Site Instruction

SI 20

PROJECT : **Hampton Manor**
PROJECT No : 1136.13
DATE : June 14, 2018

Title: Mechanical Floor Precast Update

CS 307

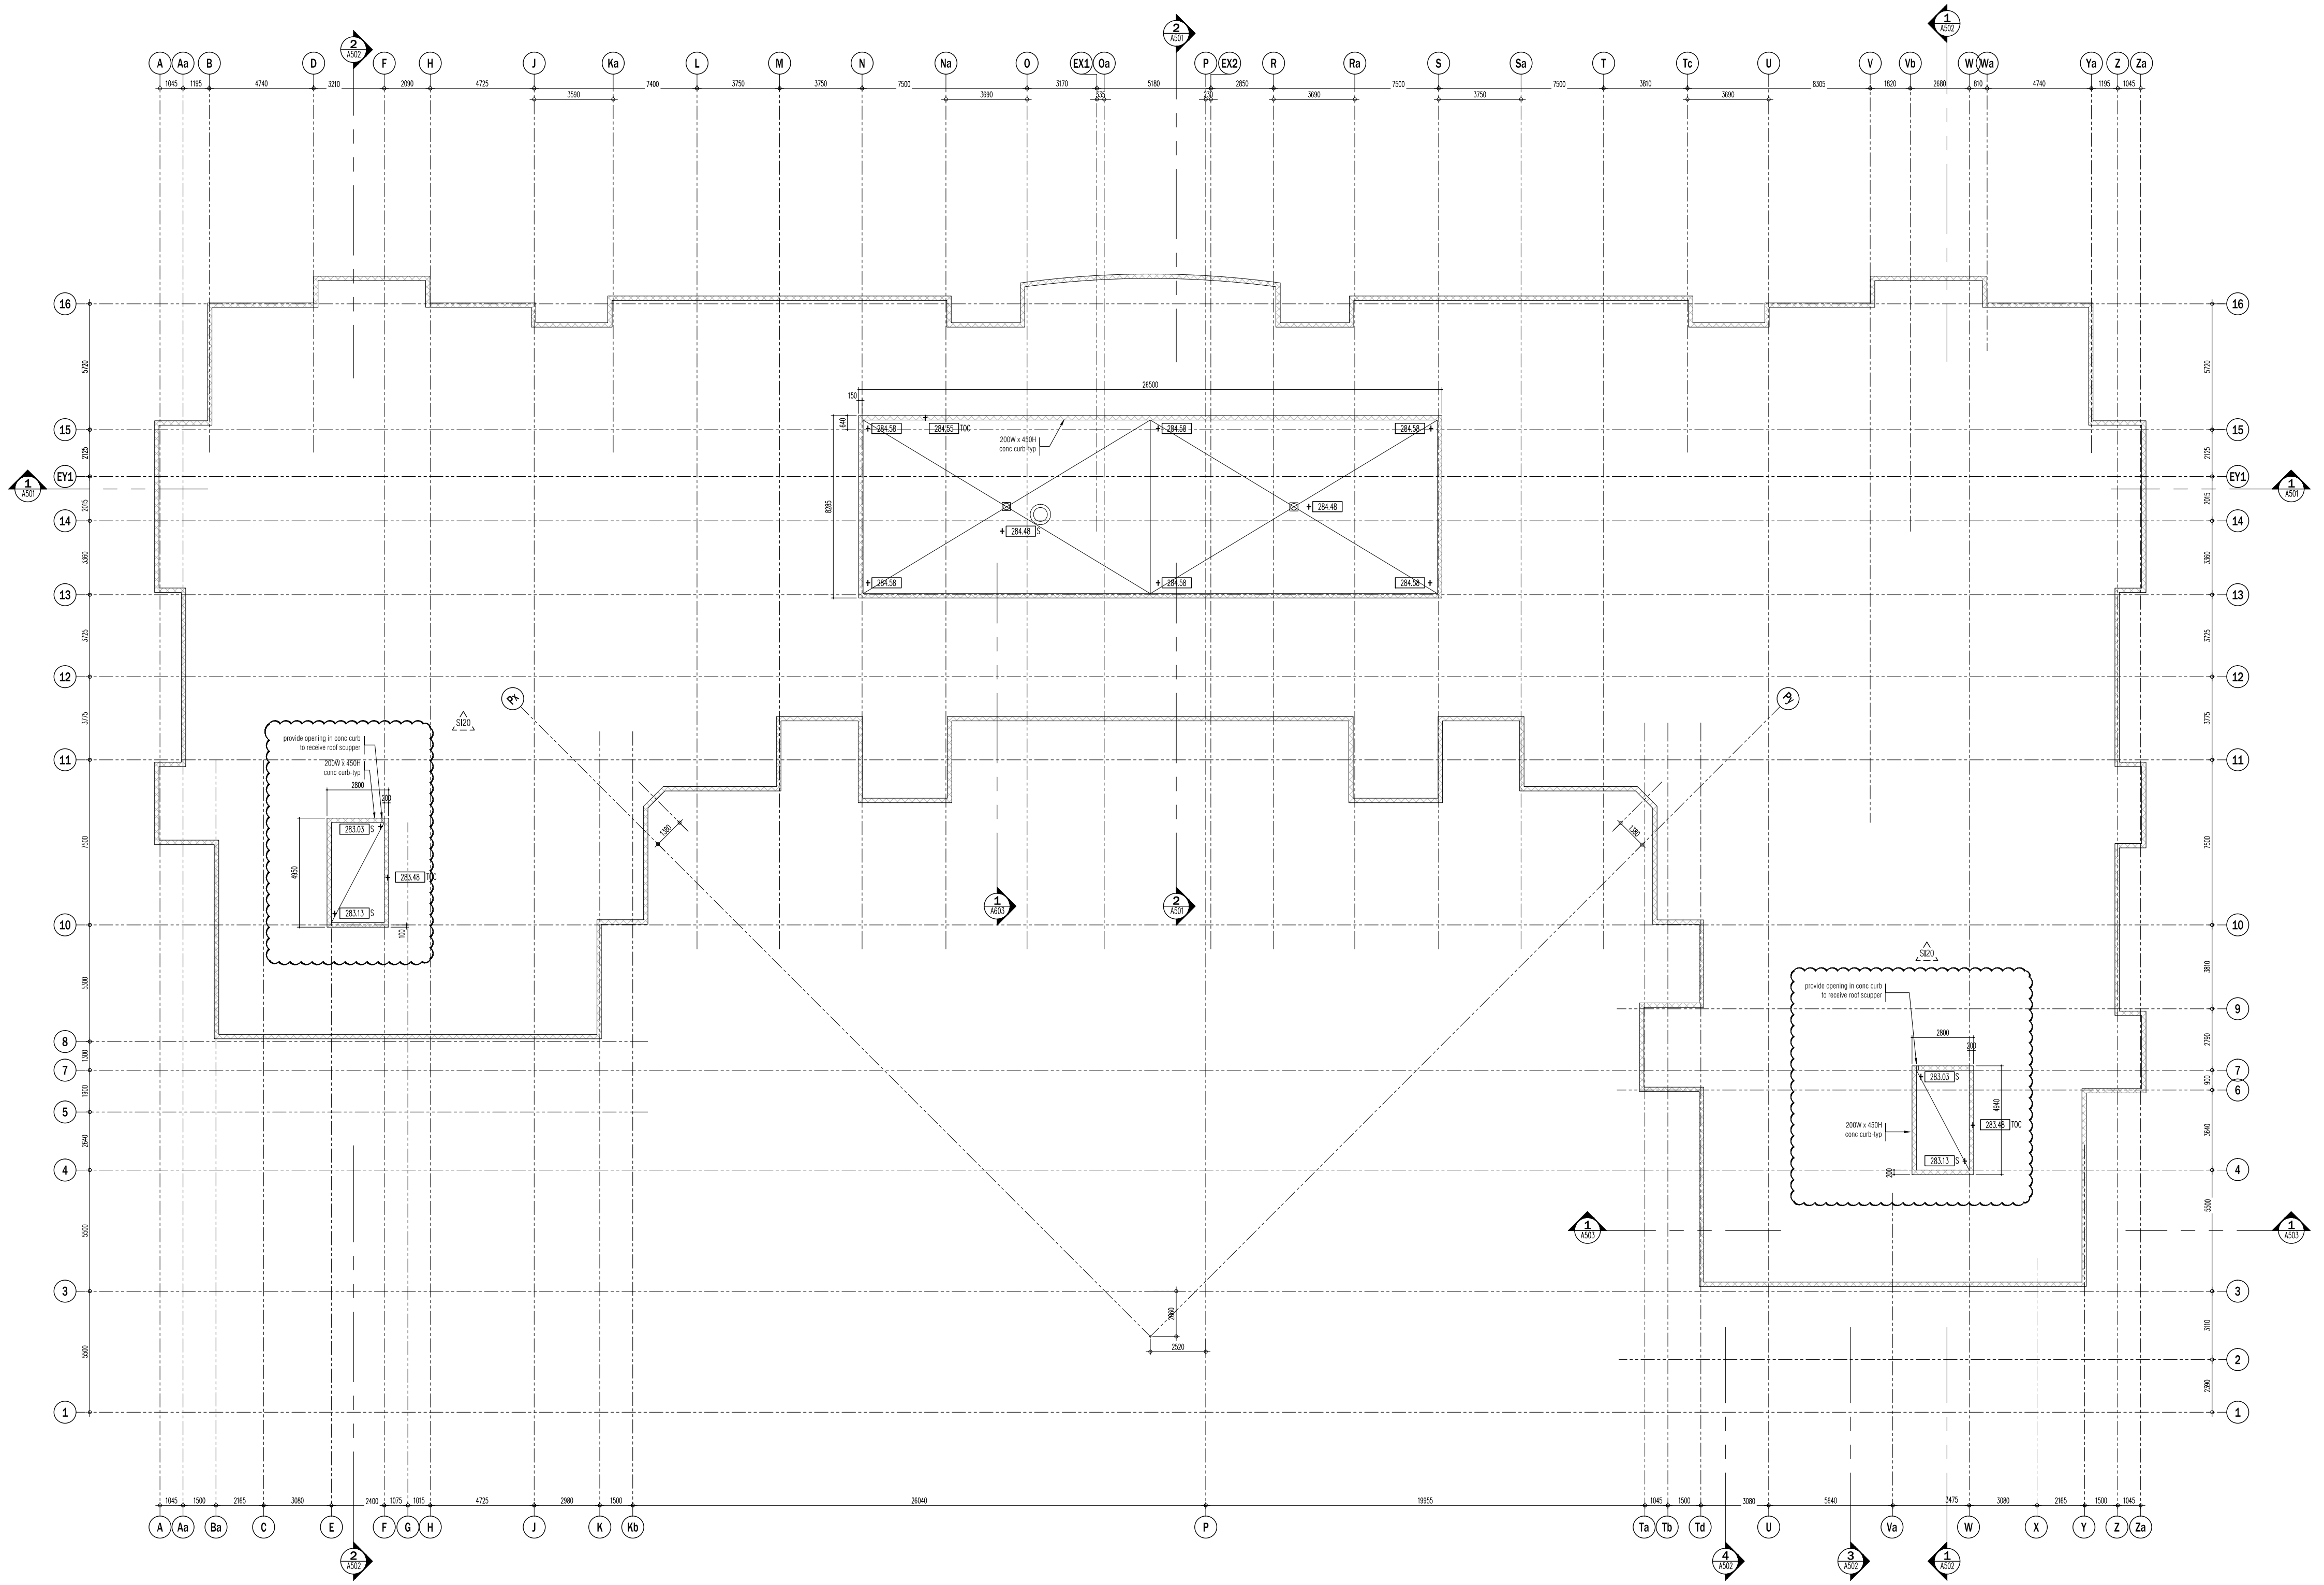
CS307 – Roof CS drawing
- Revising roof curb for precast at stair A & B.
